[IJRER] Editor Decision

We have reached a decision regarding your submission to International Journal of Renewable Energy Research (IJRER), "Implementation and Performance Analysis of a Single Phase Synchronization Technique based on T/4 Delay PLL".

Response to Reviewers

Fig.3. Hardware block diagram

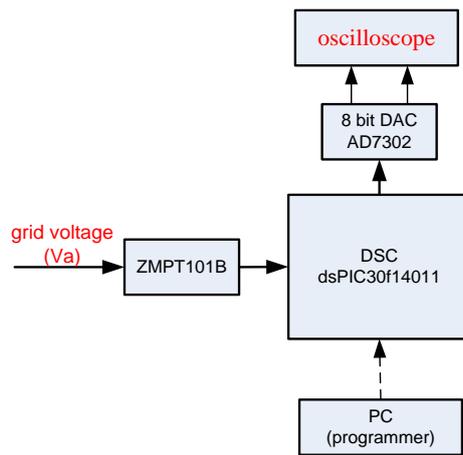
1. This paper presented the performance comparison at steady-state conditions, I suggest the response performance be provided at the conditions of frequency change and phase change.

1. Thank you very much for your suggestion. However, due to in our work, the source of the voltage signal in which the phase angle will be estimated is derived directly from the electrical grid (as shown in Fig 3 below), so in this our experiment, we practically could not change the frequency of the voltage signal.
